Testimony before the Zoning Commission of the District of Columbia
Walter Reed Proposed Rezoning Map and Text Amendments, Case #14-22
April 2, 2015

Walter Reed Proposed Rezoning Map and Text Amendments – April 2, 2015 – DC Zoning Commission
Faith Wheeler and Sara Green

RESOLUTION #15-0202
Recommendations Regarding ZC 14-22,
Text and Map Amendment to Create and
Implement the Walter Reed Zone
Proposed for Adoption February 23, 2015

Exhibit 4-118: Town Center Site Section. Source: Perkins+Will.

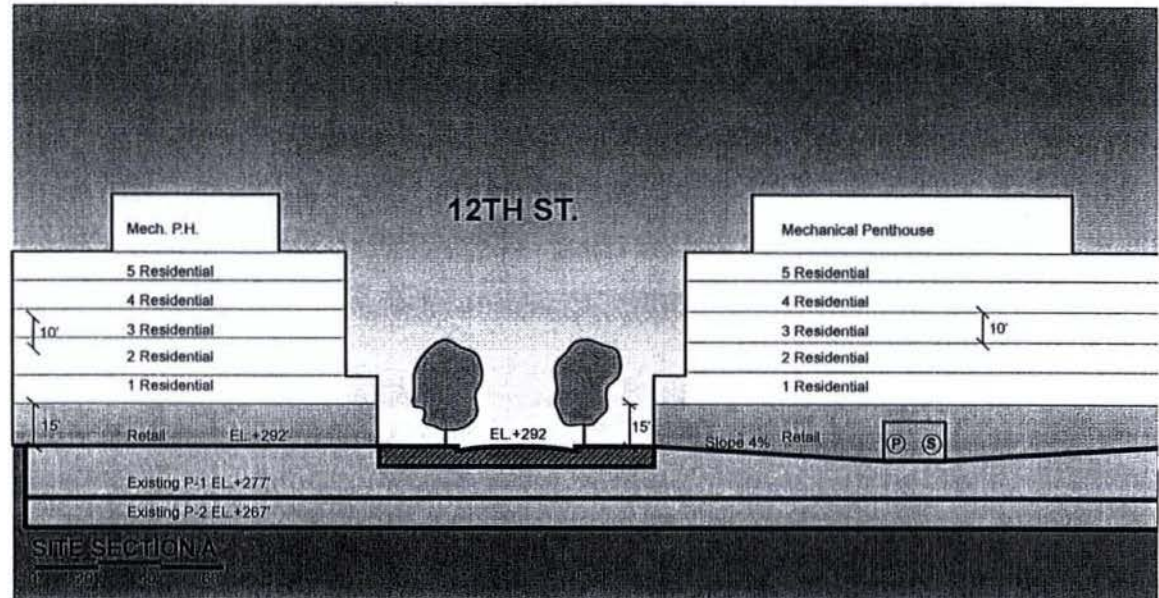
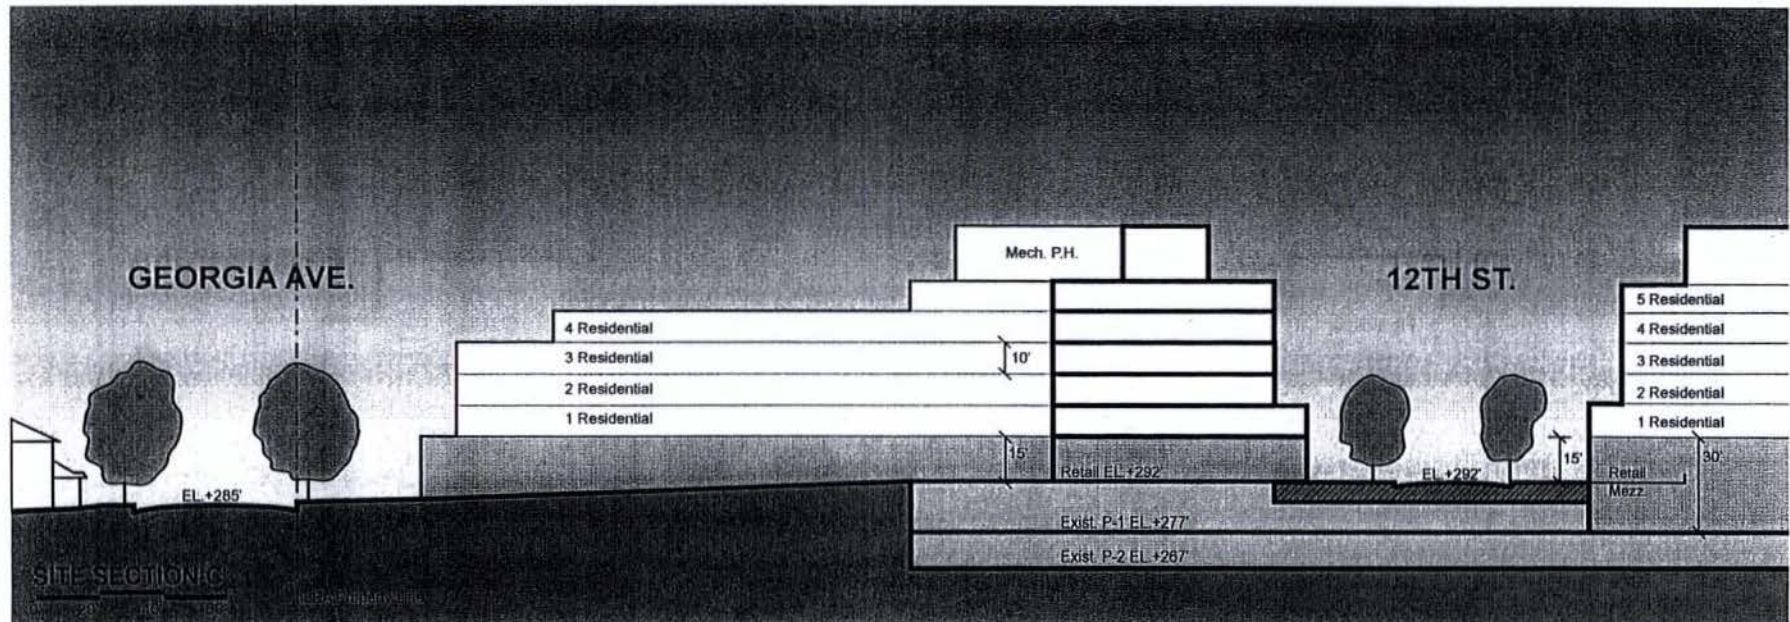
The drawings on Pages 86 and 87 of the Small Area Plan clearly show buildings that are 65 feet above grade on both the 12th and 13th Street sides. So, OP is calling for a 30 percent increase in height over the Small Area Plan (See attached Section 3, Redevelopment Framework Recommendations, 3.3 Sub-Area Urban Design Principles, Exhibits 4-118, 4-117, 4-120, and 4-121 on pages 86 and 87)

Also, note that these exhibits are from the OP web site and that OP staff have assured us that they are the final, adopted SAP, despite the caption “Progress Internal Draft – For Review Purposes Only” on the top of the page.

Therefore, the claim that OP and the developer make that the SAP specifies heights of up to 85 feet is inaccurate. Heights at the Town Center should be limited to 65 feet MOR. The community should be able to review any proposed design with a height above that limit.
